Item No. 10.2.1
Regional Centre Community Council
February 24, 2021

SUBJECT: Case 23161: Appeal of Site Plan Approval – 6459 Bayers Rd., Halifax

6459 Bayers Rd.,
Halifax - New 8 Unit
Building

① Elevation - Side (1) (Small Scale)
1/16" = 1'-0"

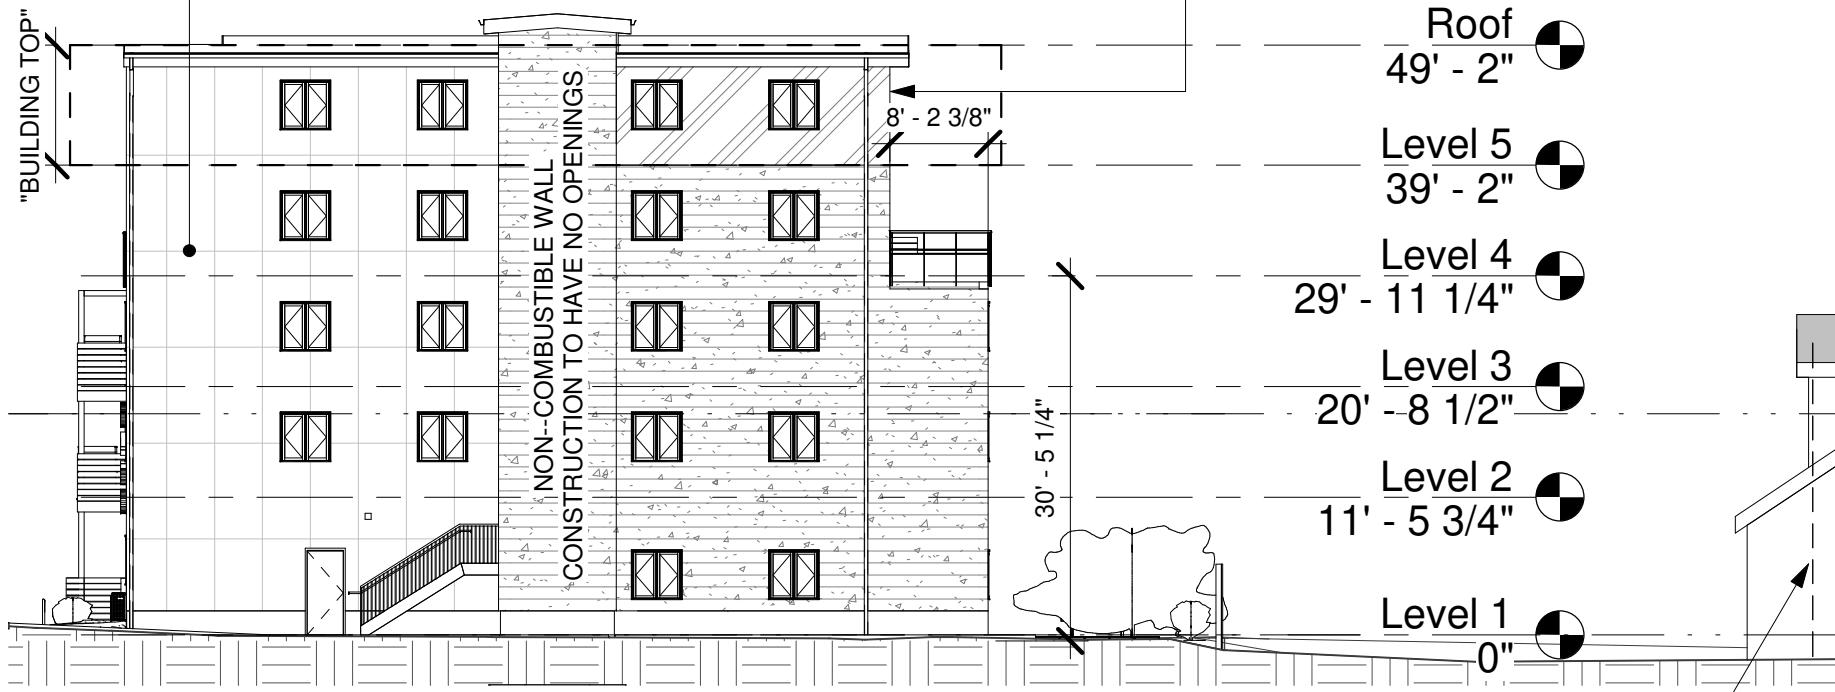
Appeal: The side exterior walls of the proposed building abut neighbouring private open spaces which abut a public right-of-way (Bayers Road). The proposed siding treatment would not meet the requirements of Section 121 as it appears to exceed the maximum 8.0 m in width without a differentiation in materials, colours or projections and recesses.

<p><u><i>Part VI, Chapter 3, Section 122: Articulation of Non-Streetwalls Fronting an At-Grade Private Open Space</i></u></p> <p>The side exterior walls of the proposed building abut neighbouring private open spaces which abut a public right-of-way (Bayers Road). The proposed siding treatment would not meet the requirements of Section 121 as it appears to exceed the maximum 8.0 m in width without a differentiation in materials, colours or projections and recesses.</p>	<p>The requirements of section 122 apply to building walls along an at-grade private open space on the same lot, not side yards on adjacent lots. As there is no at-grade private open space along the sides of the building, the requirements of section 122 do not apply to these walls.</p>

Project Number	20-072
Date	2020.11.20
Scale	As indicated
Sheet	A3

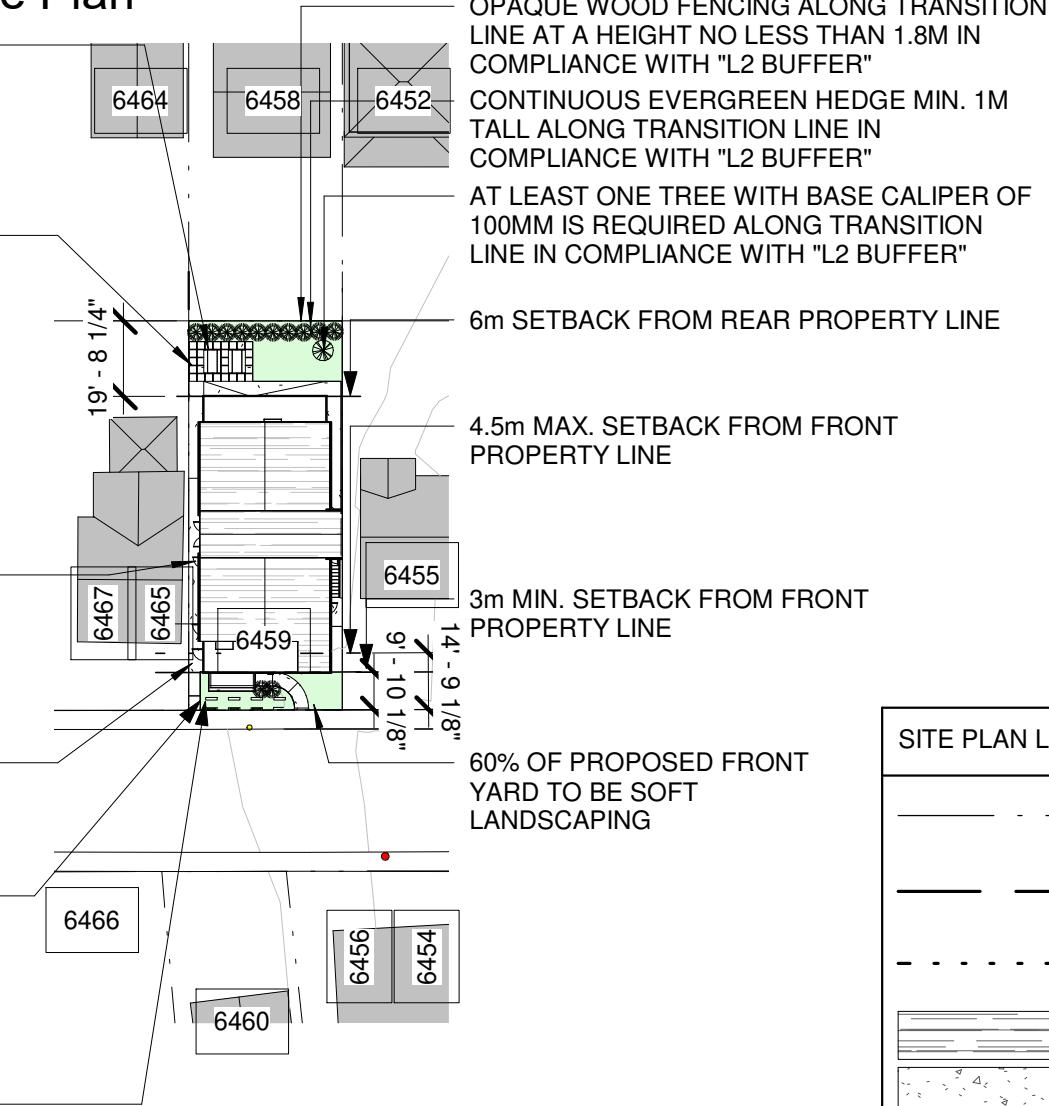
Appeal: No dimensions have been given for the walkway connecting the at-grade private open space for the unit fronting Bayers Road and the Bayers Road sidewalk. On the site plan it appears to be less than 2.0 m in width based on the dimensions provided for the 3.0 m building setback.

Appeal: a new deciduous tree with a base caliper of at least 100 mm is shown on the site plan however, it is located at the far side of the rear yard and not adjacent to the seating area offering little weather protection for those using the seating area. The site plan refers to a separate zoning requirement for the tree which relates to requiring landscape buffers along the transition line rather than weather protection.

<p><u><i>Part VI, Chapter 2, Section 114: At-Grade Private Open Spaces Abutting a Public Sidewalk</i></u></p> <p>No dimensions have been given for the walkway connecting the at-grade private open space for the unit fronting Bayers Road and the Bayers Road sidewalk. On the site plan it appears to be less than 2.0 m in width based on the dimensions provided for the 3.0 m building setback.</p> <p>The public realm and relationship of the building to the street could be improved by having a deeper front patio for the at-grade unit fronting Bayers Rd. This would better relate to the street and improve the usability of this space particularly for persons with mobility challenges who may otherwise benefit from an at-grade dwelling.</p>	<p>The open space in front of the grade-related unit is a patio, which is required under section 90(4)(a) of the land use bylaw and must be a minimum depth of 1.5 metres. The patio is considered a required part of the building, and as such, does not constitute an at-grade private open space, and does not have to meet the 2 metre pedestrian access requirement.</p> <p>Accessibility considerations are contained within the building code, not the land use bylaw. Before a construction permit can be issued, the Building Official will have to be satisfied that the units meet any applicable accessibility requirements.</p>

<p><u><i>Part VI, Chapter 2, Section 116: Weather Protection for At-Grade Private Open Spaces</i></u></p> <p>A new deciduous tree with a base caliper of at least 100 mm is shown on the site plan however, it is located at the far side of the rear yard and not adjacent to the seating area offering little weather protection for those using the seating area. The site plan refers to a separate zoning requirement for the tree which relates to requiring landscape buffers along the transition line rather than weather protection.</p>	<p>Weather protection for the at-grade private open space is provided by the referenced deciduous tree, as well as the balconies which cantilever over the rear entrance to the building, which are both listed as options in section 116. While the new deciduous tree is required as part of the landscaping buffer, there is nothing in the bylaw which precludes the use of this tree to satisfy both the requirements for weather protection and landscaped buffering.</p>
